SANITARY SEWERS

TO BE CONSTRUCTED IN
 TRACT NO. 46525

PRIVATE CONTRACT NO. 11053
 INDEX 1705
 2 SHEETS, 4 PAGES

TRACT NO. 46525

P.C. 11053 PAGE 2
 REVIEWED BY: *Sandy G. Balala* 1/19/90
 DATE

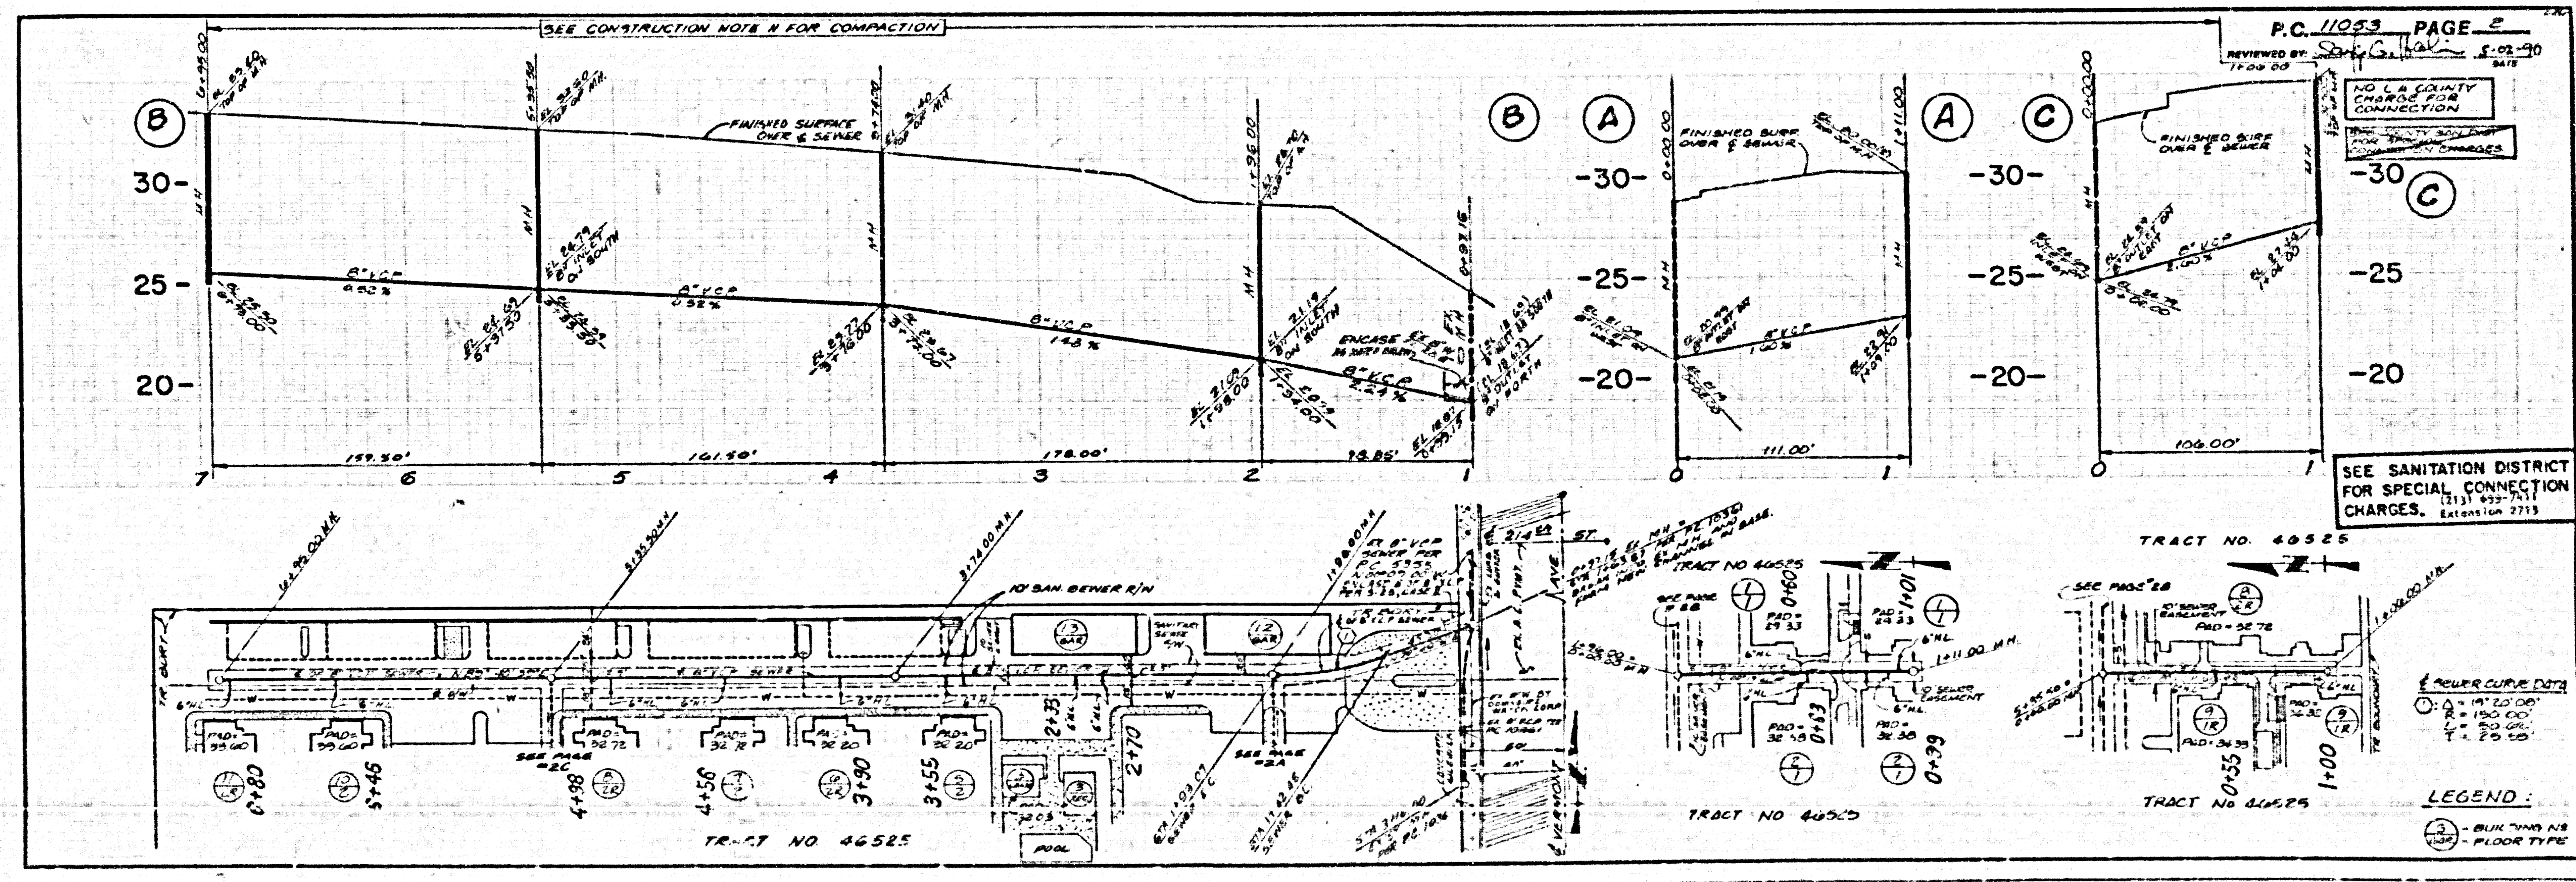
PLAN REVISION NOTE:
 REVISION NO. DATE
 1. DELETE PAGES #3 & #4.
 2. TRANSFER #6 TO #2.C.
 3. EXTEND MAIN LINE SEWER TO STA. 0+99.00
 4. RELOCATE HOUSE LATERALS
 5. CHANGE GRADE FROM 25.11 TO 25.00 THROUGH STA. 3+76.00 TO 4+81.00
 APPROVED: *Sandy G. Balala* 1/19/90
 CHIEF OF PUBLIC WORKS
